SERVICE BULLETIN

FUJI HEAVY INDUSTRIES LTD.

NO : FAS-050

1. SUBJECT : Improvement in Instrument Illumination.
2. AIRCRAFT AFFECTED : FA-200 Series Serial Nos. 1 thru 100.
3. PRIORITY : Optional.
4. REASON : In order to provide effective illumination that instrument can be easily seen during night.
5. DESCRIPTION : Instrument illumination light to be added and existing light location changed.
6. ACCOMPLISHMENT : Optional.
7. APPROVAL : JCAB Approval NO-TOKYO-012 March 1, 1971.
8. PARTS REQUIRED : The following parts are required to perform the rework.

FIG. 1

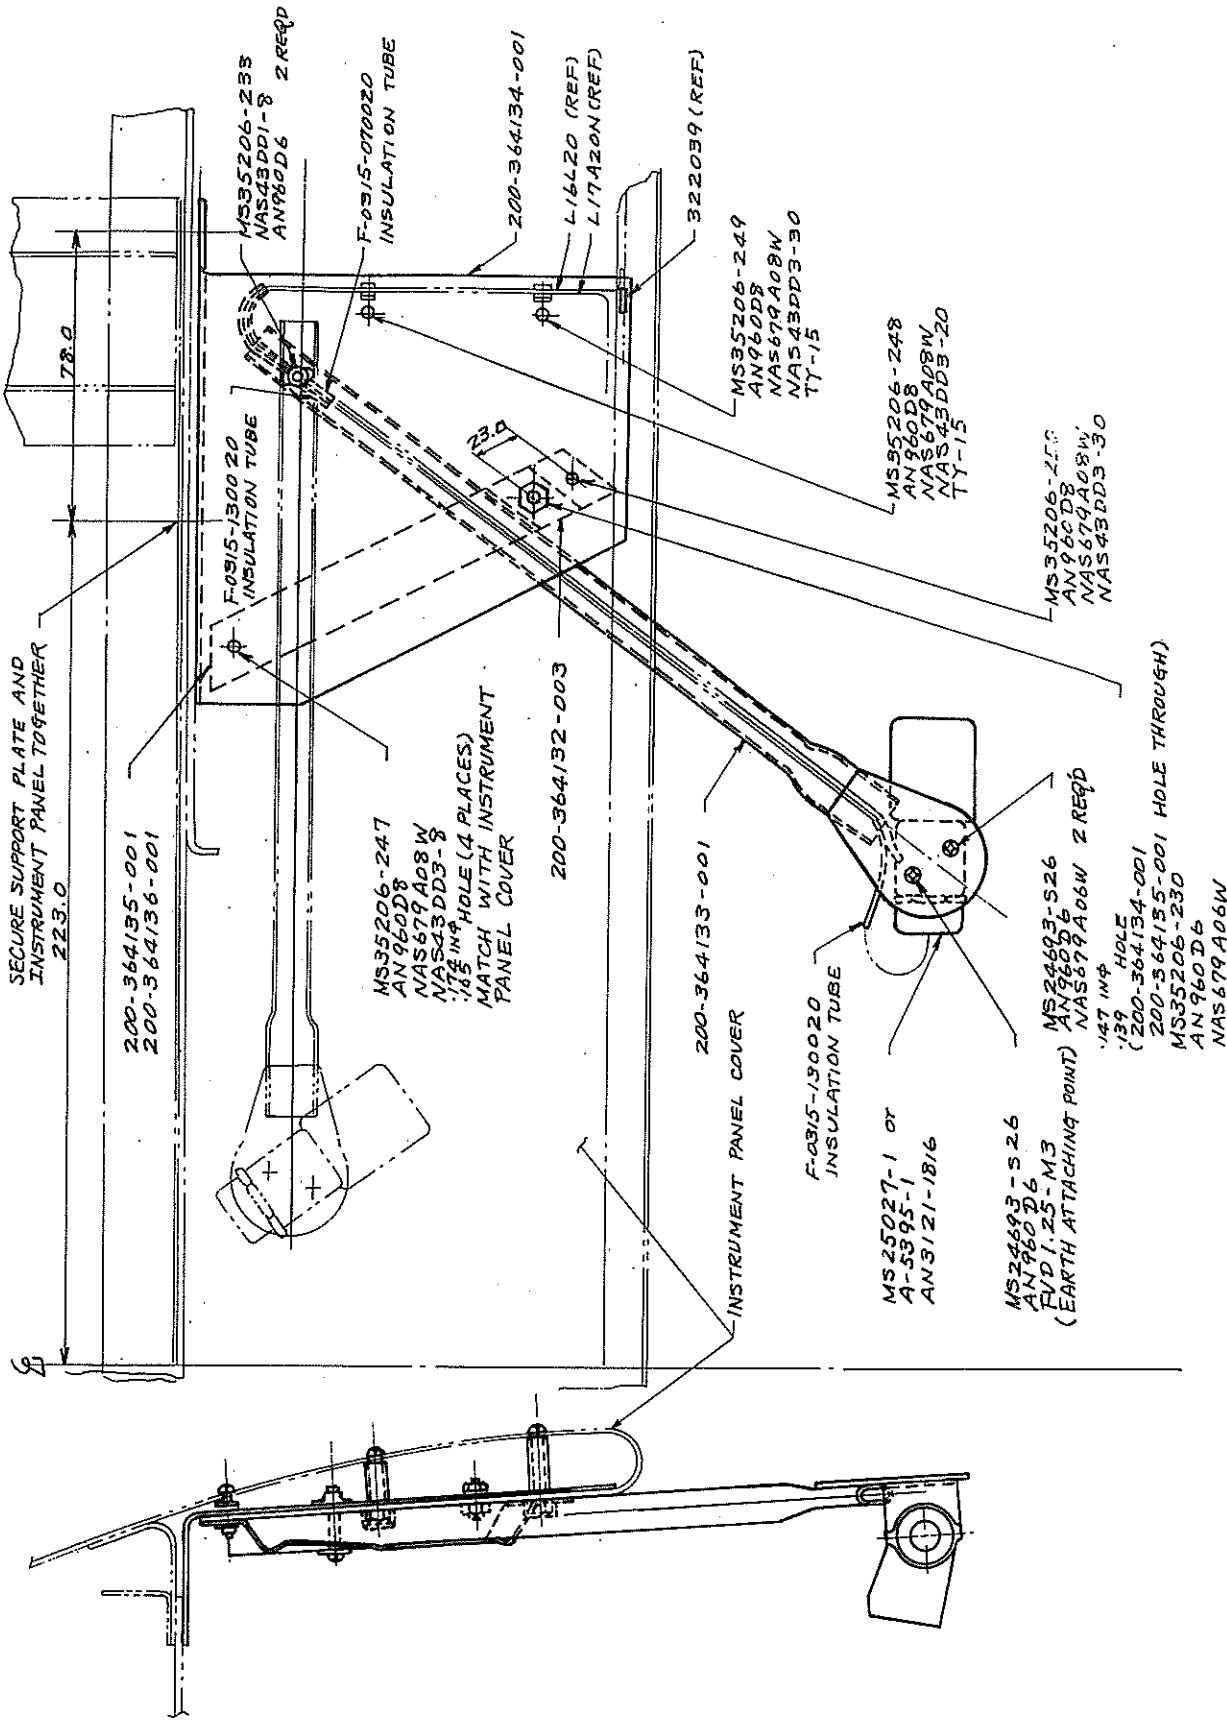
- o. Insert insulation tubes, F-0315-070020 and F-0315-13020, into each end of arm assembly, 200-364133-001, as shown in figure 1. Through these tubes, pass harness, L-17A20N (earth) and L16L20 (power supply). Attach terminal, FVD1.25-M3, to the end of the earth wire, and then install light assembly, MS25027-1 (or A-5395-1), and the terminal together on the arm assembly, using screws, MS24693-526, washers, AN960D6, and nuts, NAS679-A06W. Connect power supply harness with the light assembly, referring to figure 6, detail C.

- p. Install the arm on the support plate assembly at the nutplate with screw, MS35206-233, spacer NAS43DD58, and washer AN960D6.
- q. Attach the assembled arm and support plate to the instrument panel cover with the arm sandwiched between bracket, 200-364135-001, and slide plate 200-364136-001. Using the four holes provided in step 14, secure with screws, spacers, nuts, and washers as shown in figure 1. Also secure the harness with ty-rap, TY-15, as indicated in figure 1.

- r. Drill a .147/.139 in diameter hole through the support plate and bracket as indicated in figure 1, and install stopper, 200-364132-003, with screw MS35206-230, washer, AN960D6, and nut, NAS679A06W.

FIG. 2

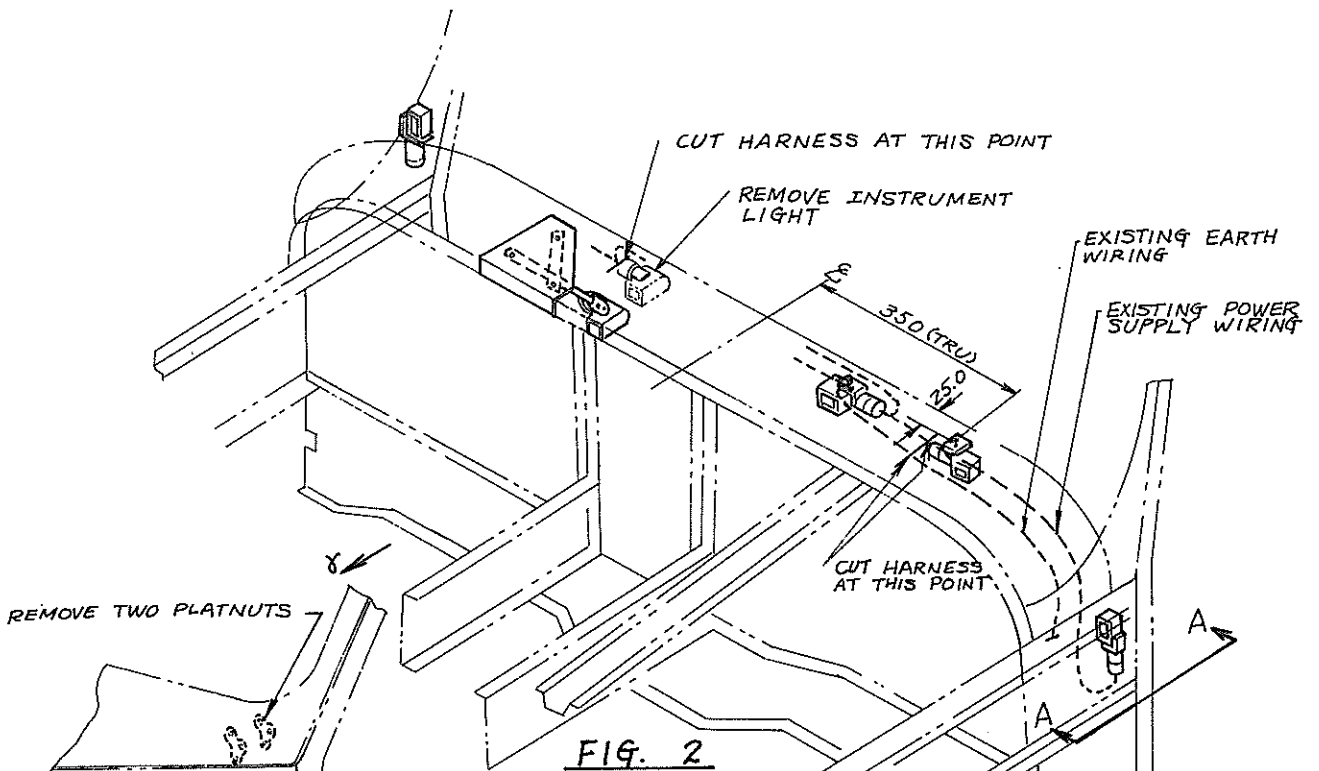
- i. Drill two light installing holes in instrument cover as shown in figure 4, area G. For dimensions, refer to figure 2.
- j. Cut right side instrument light harness as illustrated in figure 2, and remove the instrument light. Temporarily position the above light in the place drilled in the preceding step 9.

- k. Power supply and earth wiring runs underneath the instrument cover. Cut the harness as illustrated in figure 2.
- l. According to illustration in figures 4 and 5, connect the harness to the instrument light positioned in step 10. At this time, connect each end of the separated earth wire to terminal, FVD1.25M3, and then install the terminal and the instrument light together as shown in figure 5.

FIG. 3 VIEW A-A

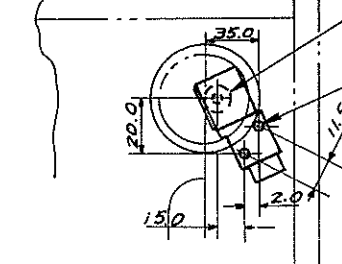
- c. Remove cover from sliding canopy left side rail.
- d. Remove front seat left side panel.
- e. Remove two attaching nutplates for instrument light that has been removed in the preceding step 2. (See figure 3).

- f. Drill two .379/.375 in diameter holes in structure as illustrated in figure 3, and install two nutplates.
- g. Drill a 6.4 mm diameter hole in panel removed in step 4, and install a grommet, MS35489-15. Also drill two .149/.139 in diameter holes in the panel. (See Figure 3.)

DRILL 6.4mm ϕ HOLE IN PANEL AND INSTALL GROMMET MS35489-15
 .379 IN ϕ HOLE (2 PLACES) IN STRUCTURE TO INSTALL PLATENUTS NAS684A06
 .127 IN ϕ HOLE (1 PLACE) IN PANEL

FIG. 4

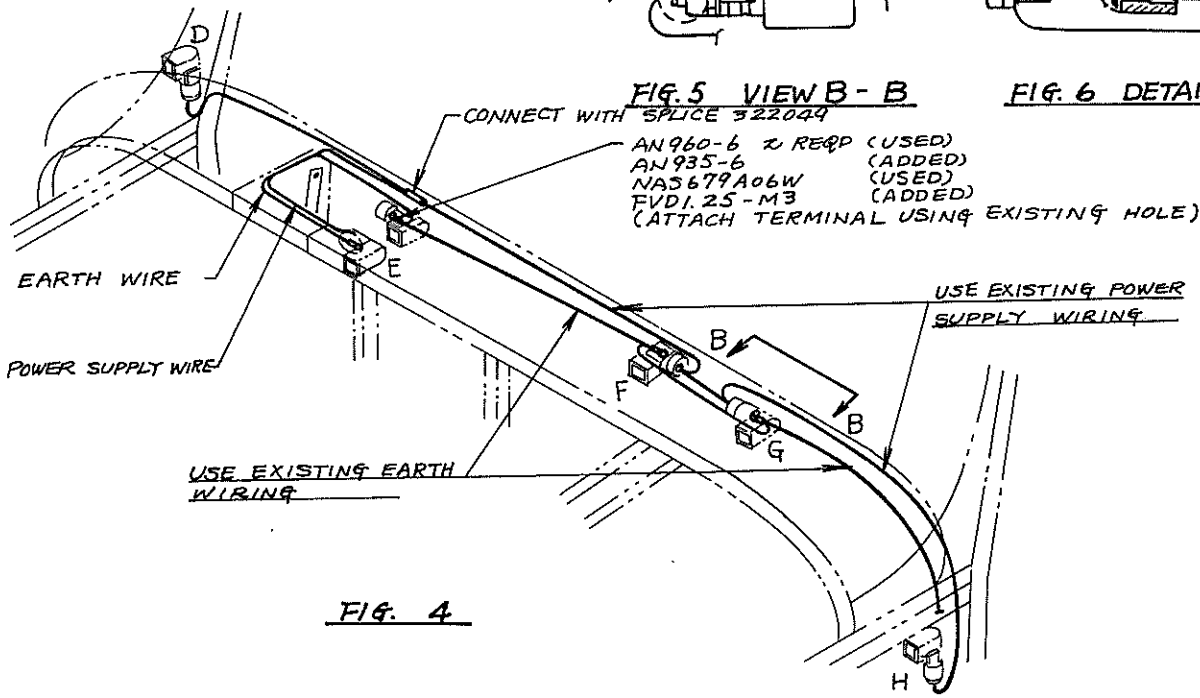
- a. Remove attaching nuts, and remove instrument cover (left) from instrument panel.
- b. Remove cover from fixed front canopy left side frame. Also remove simultaneously instrument light shown in figure 4, area H, and, with cover removed, separate instrument harness at the adjoining splice.

- m. The instrument lights shown in figure 4, areas D and F, to be left in the same positions.
- n. Hold support plate, 200-364134-001, in position, and, using four holes in the support plate, drill four .174/.165 in diameter holes in instrument panel cover.

- s. Using splice, 322049, connect the harness separated in step 10 to the power supply harness from the sliding instrument light as shown in figure 4. Also connect the earth harness from the same light to the existing earth with terminal, FVD1.25-M32, at the point shown in figure 4. Attach the terminal as illustrated in figure 5, view B-B, using one of the two holes previously used for installing light; the other hole is no longer required, and must be plugged with screw.
- t. Upon completion of the above procedures, carefully check for proper wiring or short-circuit, and then perform lightening test.
- u. Install cover on sliding canopy left side rail.
- v. Install cover on fixed front canopy left side frame.
- w. Install instrument cover (left) on instrument panel.
